# 1955 PITTWATER ROAD, BAYVIEW

S4.55 AMENDED PLANS

DRAWING LIST

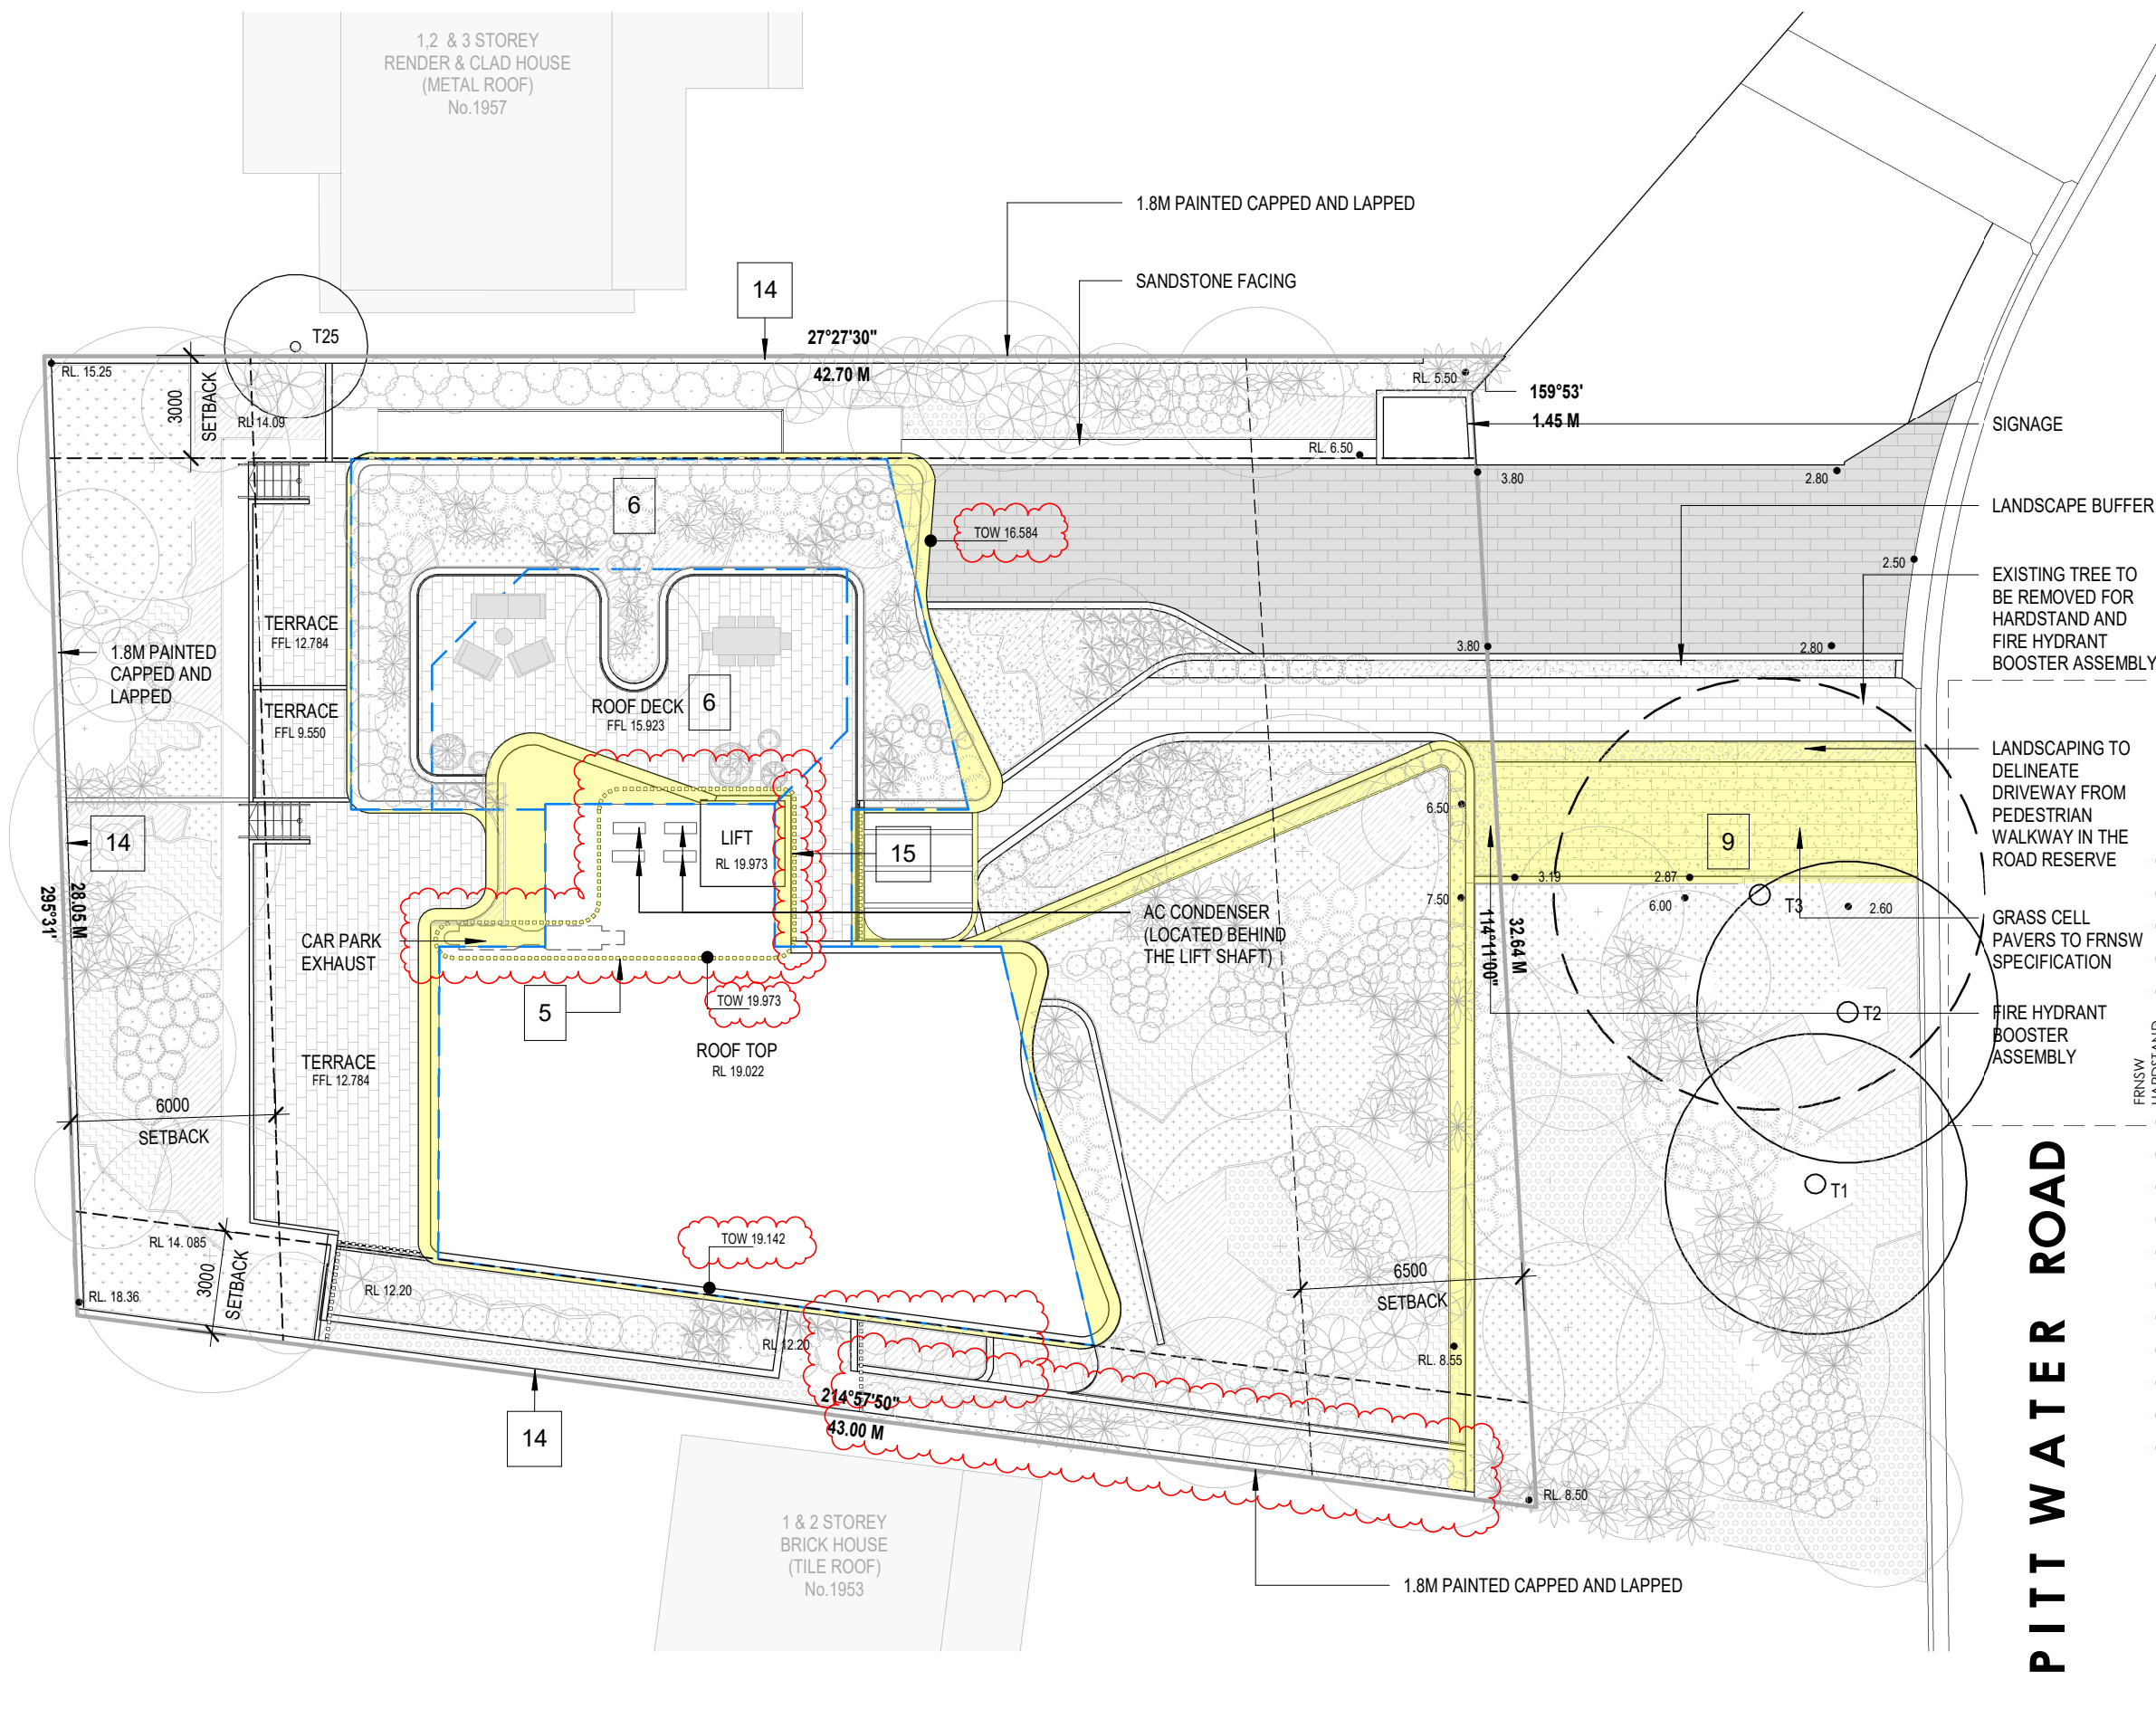
- 1. Entry Pedestrian Ramp** - Increased pedestrian ramp width to 1600mm for accessibility
- 2. Building Entry** - New awning and vertical louvre screen to increase sense of entry.

- 3. Balcony Articulation** - New curved balconies for improved aesthetics. Increase in outdoor private open space area and solar access for improved amenity

- 4. Fencing** - New fencing to provide safety and security
- 5. Roof** - New rooftop plant enclosure to comply with services requirements
- 6. First Floor Roof Deck/ Landscaping** - Change in configuration of First Floor roof deck to integrate with overall building aesthetics. New landscape buffer around perimeter of First Floor roof deck for improved privacy and softening of built form

- 7. Roof & Floor RL** - Adjustment in floor-to-floor heights to reflect structural and building services requirements.
- 8. Vehicular Access** - Design development to comply with accessibility & Australian Standards.

- 9. FRNSW Requirement** - to provide hardstand & fire hydrant booster assembly, requiring removal of tree T3 (Refer to Arborist Report).
- 10. Carpark Floor Plan** - Parking re-configuration within approved footprint.

- 11. Lower Ground Floor Plan** - Increase in Unit 4 storage area to accentuate recess and alignment between the two modulated built forms. Louvred door and panels for maintenance and ventilation. New landscaped terrace to integrate with cascading balconies above and overall building aesthetics.

- 12. Unit layouts** - Internal reconfiguration and increase in unit size for improved amenity.
- 13. Elevations** - Removal of wall break in east elevation of Units 3 and 4. Revised façade and window treatments associated with plan amendments

- 14. Boundary Fence** - 1.8m high painted fencing capped and lapped in Dulux 'Winter Fog'
- 15. Vertical Screening** - Continuation of vertical screening over lift shaft to accentuate recess between the two modulated built forms

- 16. Proposed Terrace Extension**

Drawing Title  
Entry Floor Plan

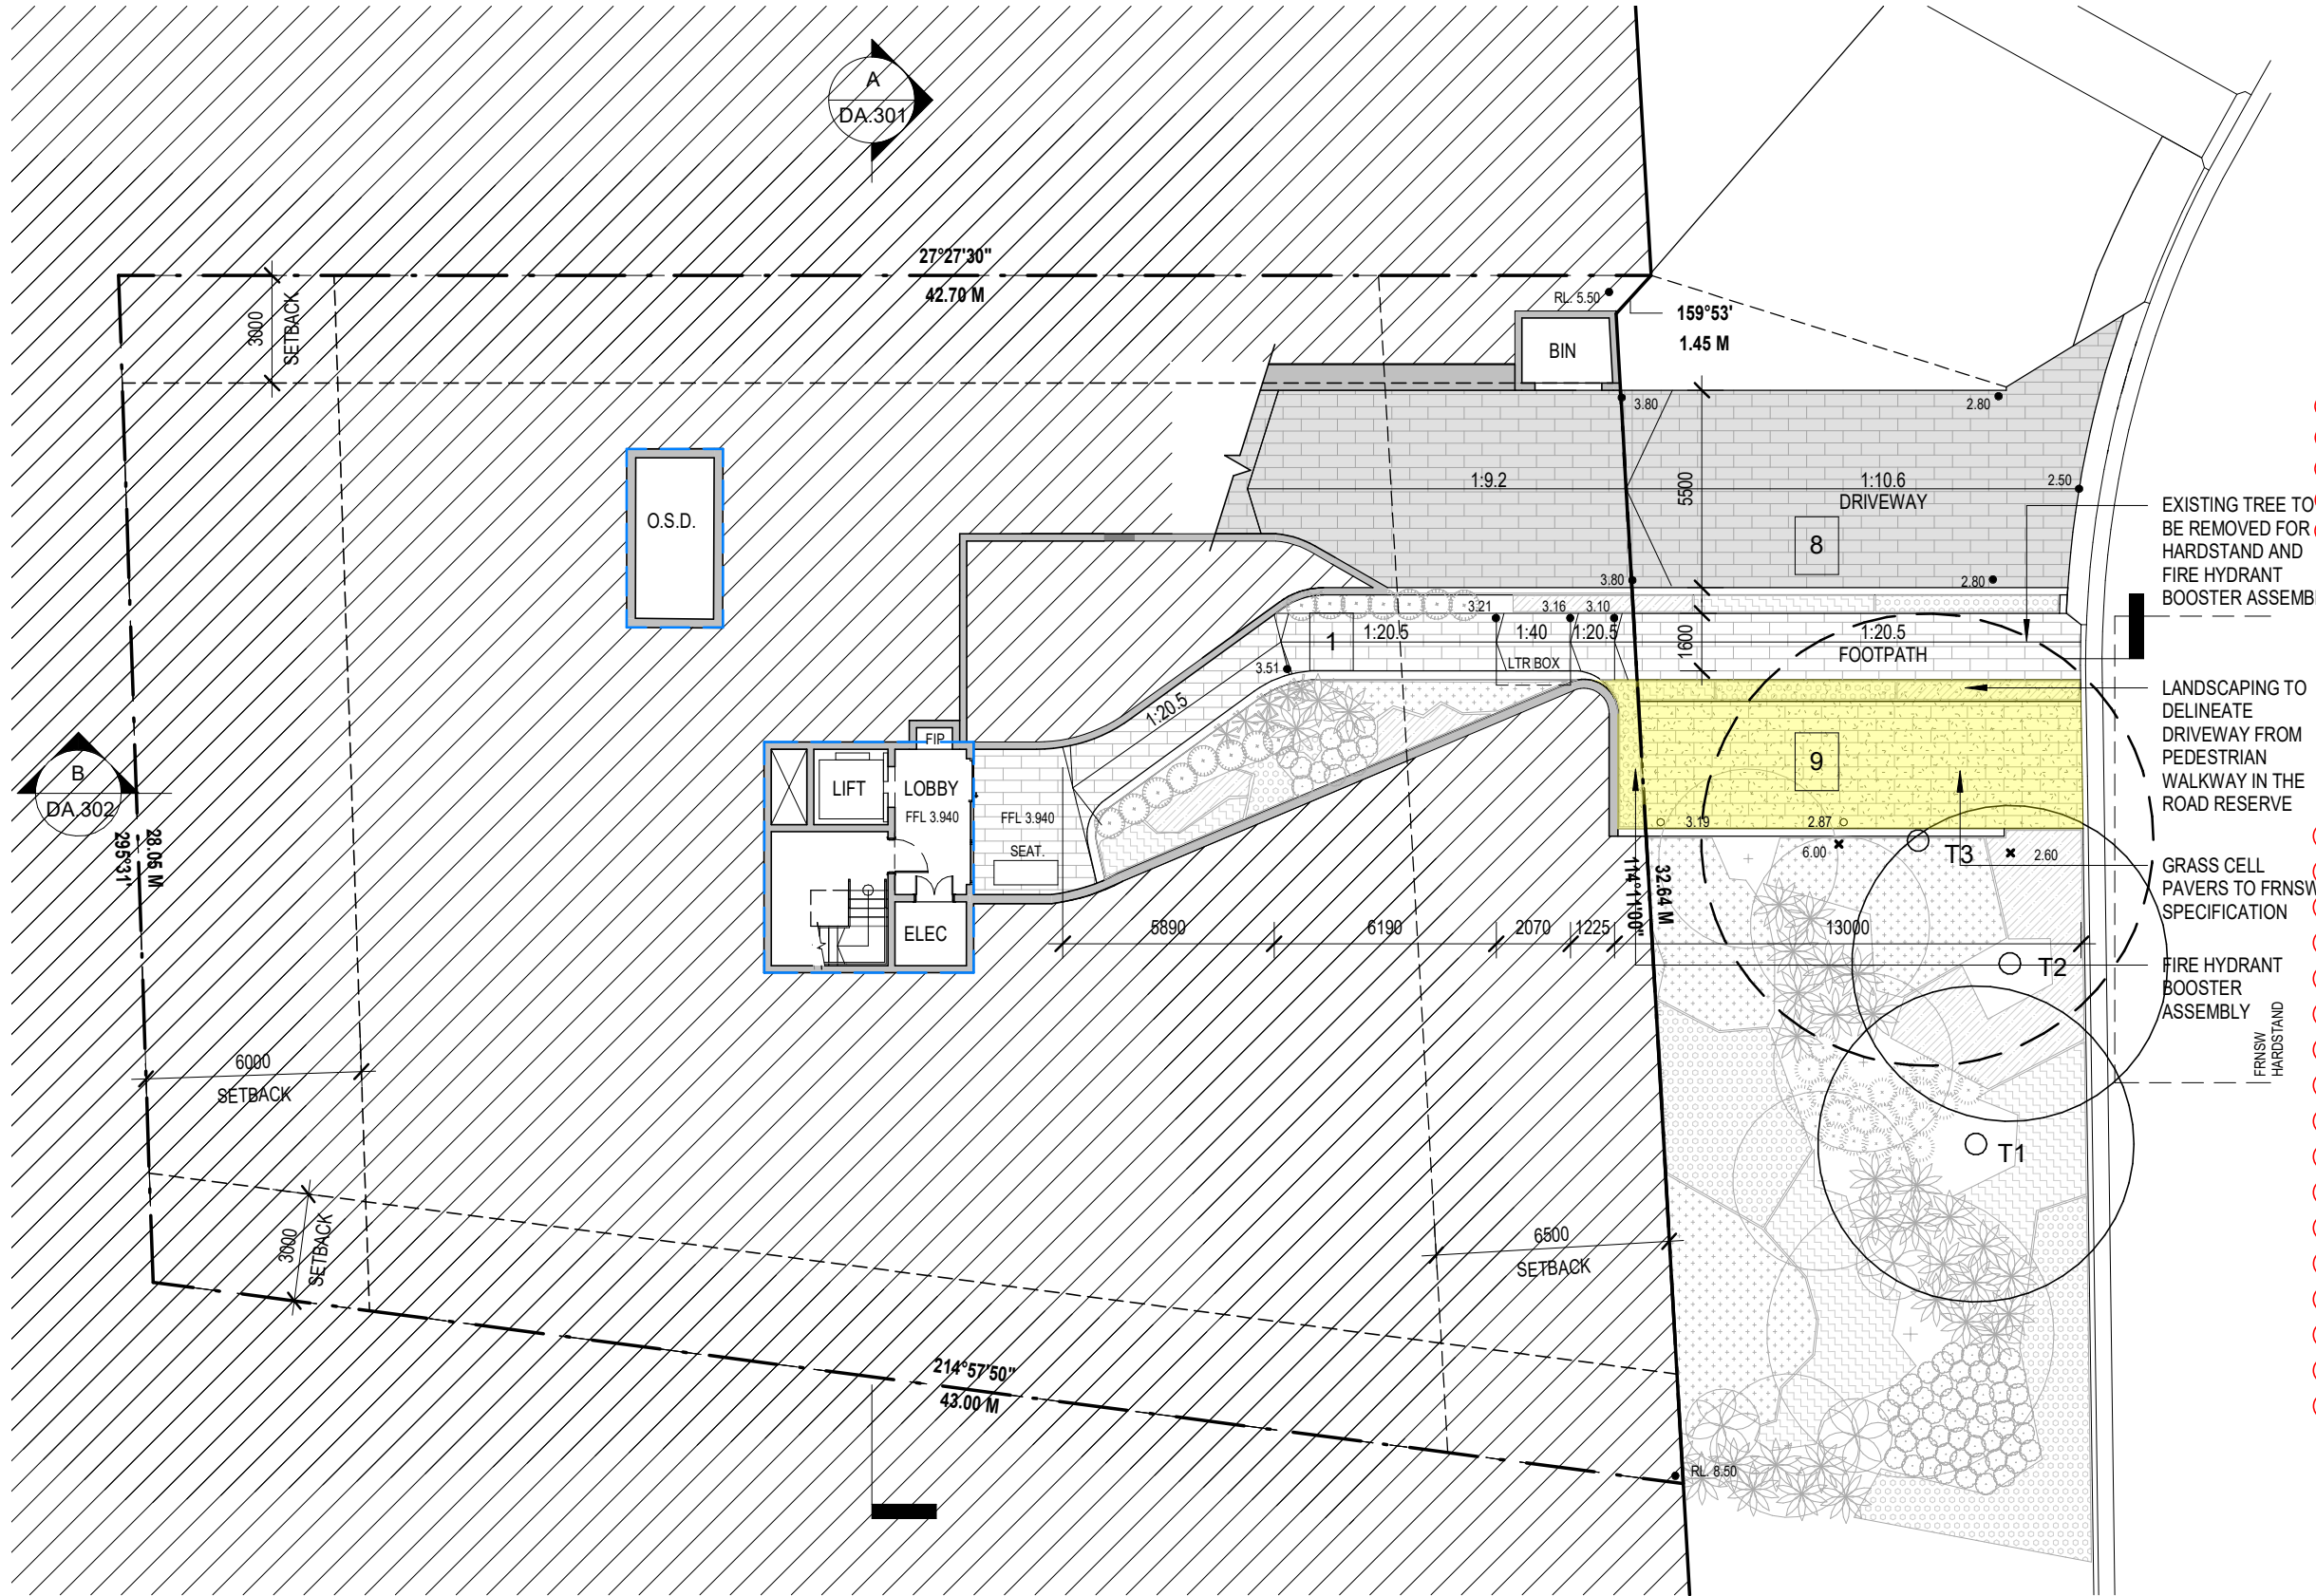
- 1. **Entry Pedestrian Ramp** - Increased pedestrian ramp width to 1600mm for accessibility
- 2. **Building Entry** - New awning and vertical louvre screen to increase sense of entry.

- 3. **Balcony Articulation** - New curved balconies for improved aesthetics. Increase in outdoor private open space area and solar access for improved amenity

- 4. **Fencing** - New fencing to provide safety and security
- 5. **Roof** - New rooftop plant enclosure to comply with services requirements
- 6. **First Floor Roof Deck/ Landscaping** - Change in configuration of First Floor roof deck to integrate with overall building aesthetics. New landscape buffer around perimeter of First Floor roof deck for improved privacy and softening of built form

- 7. **Roof & Floor RL** - Adjustment in floor-to-floor heights to reflect structural and building services requirements.
- 8. **Vehicular Access** - Design development to comply with accessibility & Australian Standards.

- 9. **FRNSW Requirement** - to provide hardstand & fire hydrant booster assembly , requiring removal of tree T3 (Refer to Arborist Report).
- 10. **Carpark Floor Plan** – Parking re-configuration within approved footprint.
